FINAL DECISION

TransGrid

Contingent Project

Project EnergyConnect

Figure 1 Capitalised overheads as proportion of total capex (TransGrid)

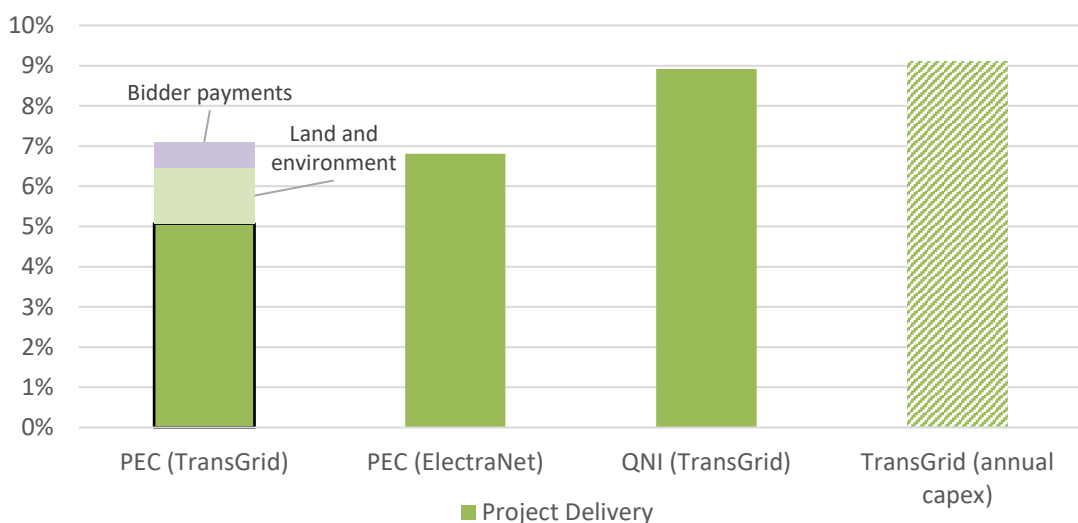
We have benchmarked TransGrid's project delivery costs because they are most comparable to TransGrid's overheads on historical projects. As shown in Figure 1, TransGrid's project delivery costs for Project EnergyConnect are significantly less than the forecast project delivery costs on its recent QNI Minor project, as well as its annual capitalised overheads.

These results are consistent with our expectations of forecast project delivery costs from a prudent operator in these circumstances. While the project is more complex than a typical brownfields project in terms of planning and project management, this is offset by the size of the project and the ability to spread fixed costs over a larger amount of material and contracting costs. This is also consistent with ElectraNet's forecast project delivery costs for its component of Project EnergyConnect, which are likely higher than TransGrid's in part due to its smaller total project costs.
